SERVICE BULLETIN

SUBJECT: ENGINE GEAR AND PUMP AIR TIMING ANGLE CHANGE PUMP MODELS AFFECTED:DB2435-4989 AND 5033

Air Timing of DB2-4989 and DB2-5033 Pump Models

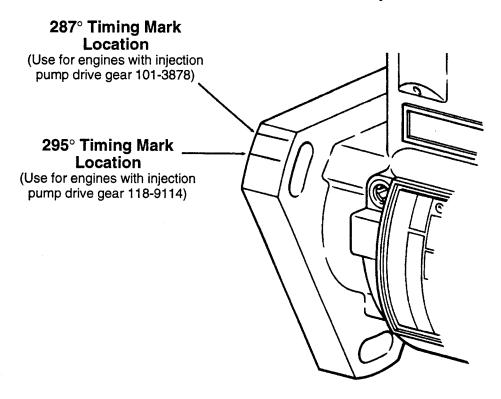
To eliminate the potential for timing problems associated with intermixing of pumps with either of the two timing angles with engines having either of the two engine gears, Stanadyne recommends placing marks at both 287° and 295° on 4989 and 5033 pumps when they are serviced as shown on page 2. It is also suggested that a copy of this bulletin be provided with each repaired or rebuilt 4989 or 5033 pump model being returned or provided to a customer so they will understand the presence of the two timing marks.
